**CHAPTER 2.0 SUMMARY OF CHANGES**

Since publication of the Draft EIR on April 8, 1996, the following changes have been made to clarify, amplify, and/or correct the first volume. New text which has been added to the DEIR is shown in redline, and text which has been deleted is presented in ~~strikeout~~ format.

FIGURE 3-7

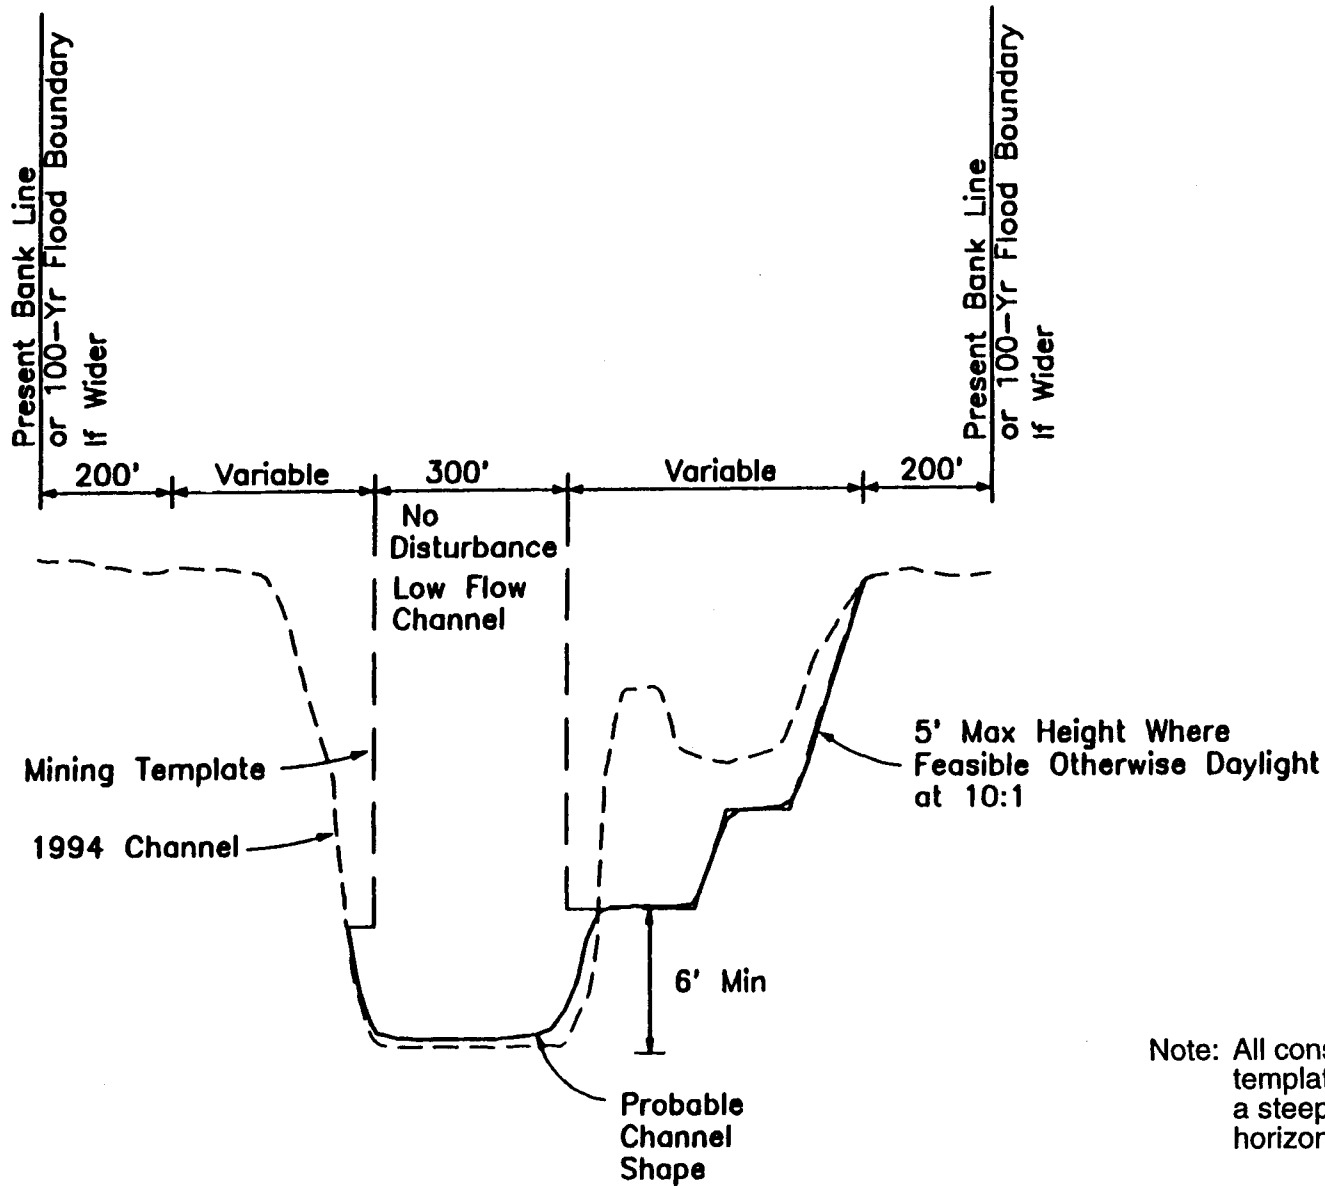
**Text Change # 33:**

Appendix C (CCIP), Figure 3-7 -- Figure 3-7 has been modified as shown.
